**Amendments to the Drawings:**

## REMARKS/ARGUMENTS

JIN, XIN ET AL

FIG. 1

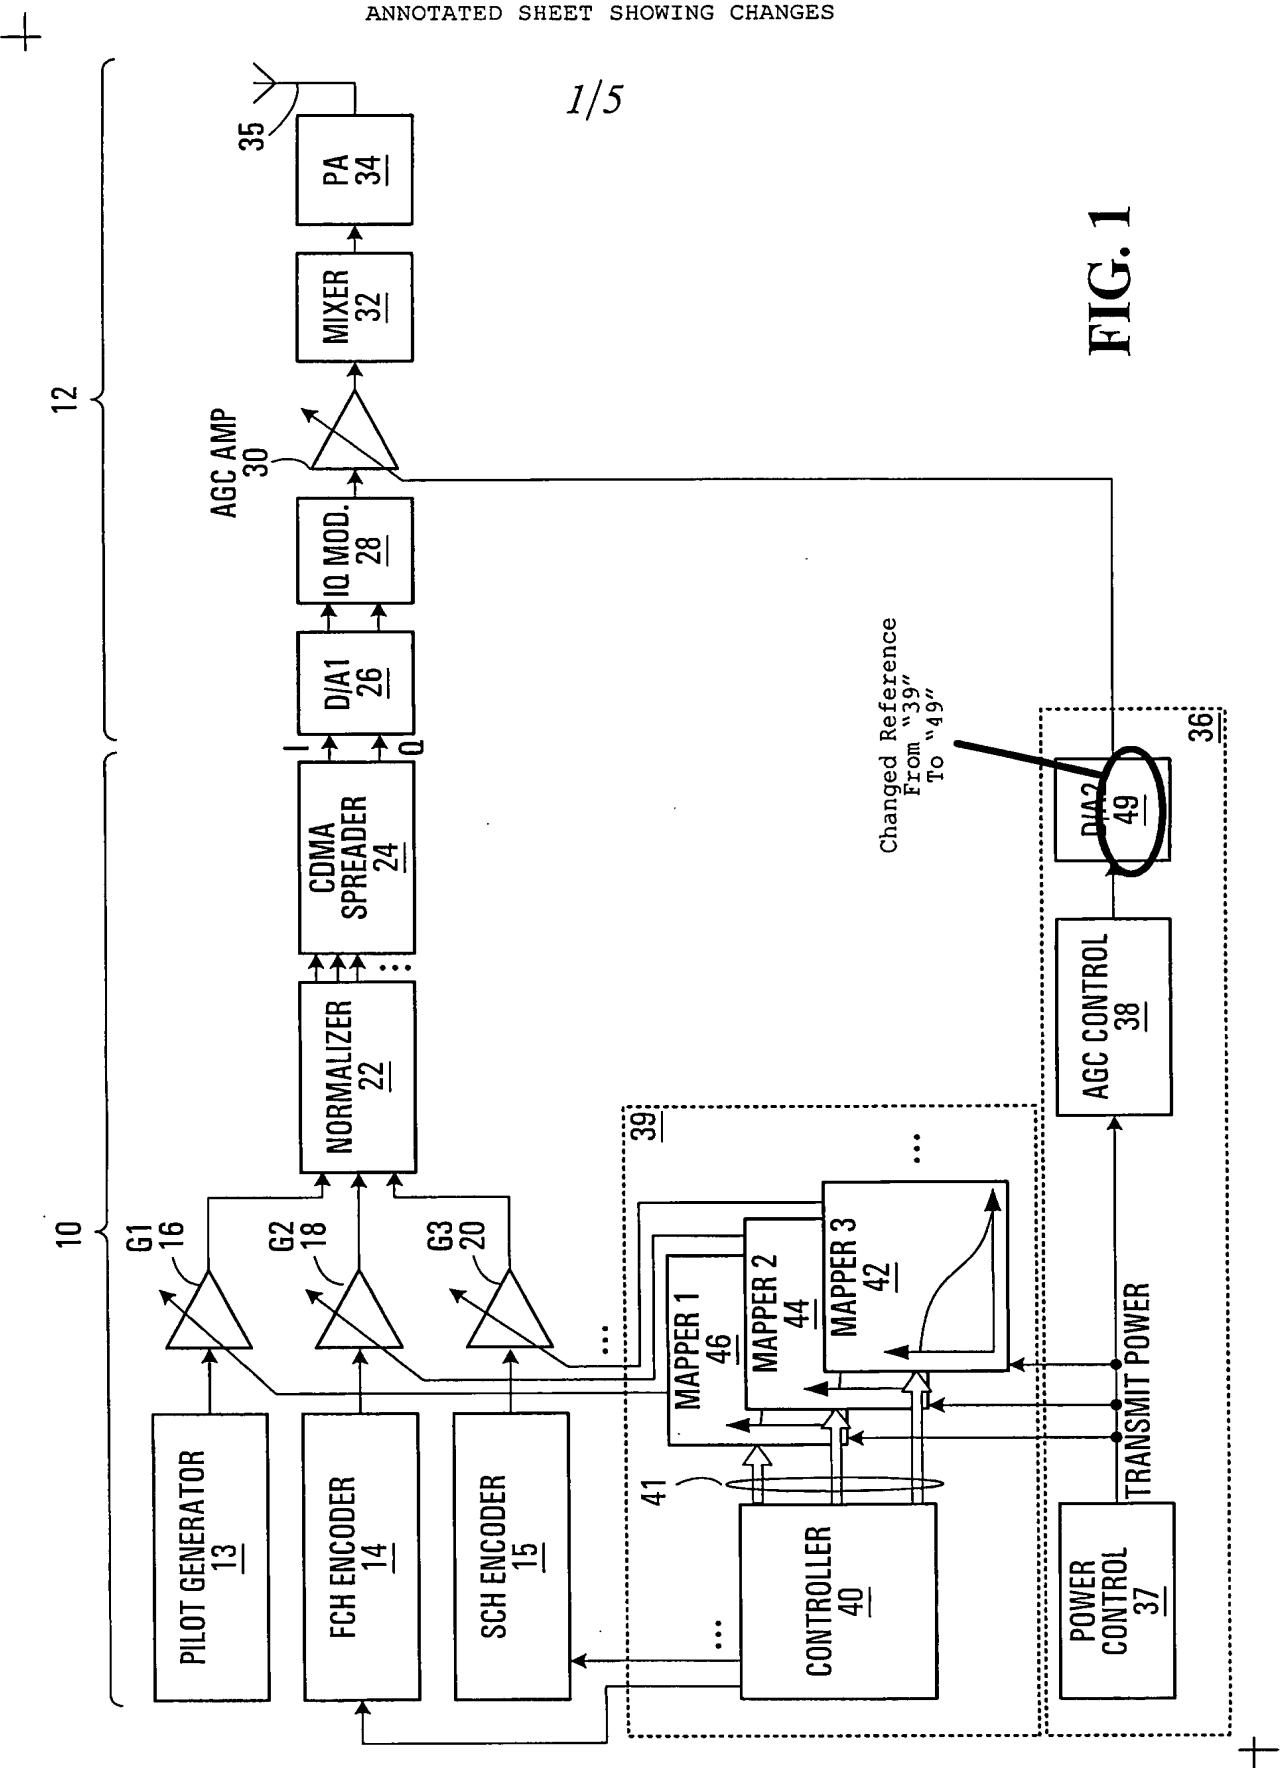
The amendment to Figure 1 on sheet 1 of 5 is the replacement of reference character 39 (D/A2) with new reference character 49. The same amendment has been made to Figure 5 on sheet 4 of 5.

In amended Figure 1, reference character 39 used to formerly identify component D/A2 has been replaced with new reference character 49. This is for consistency with the amendment made to the specification discussed above. Figure 5 has been similarly amended.
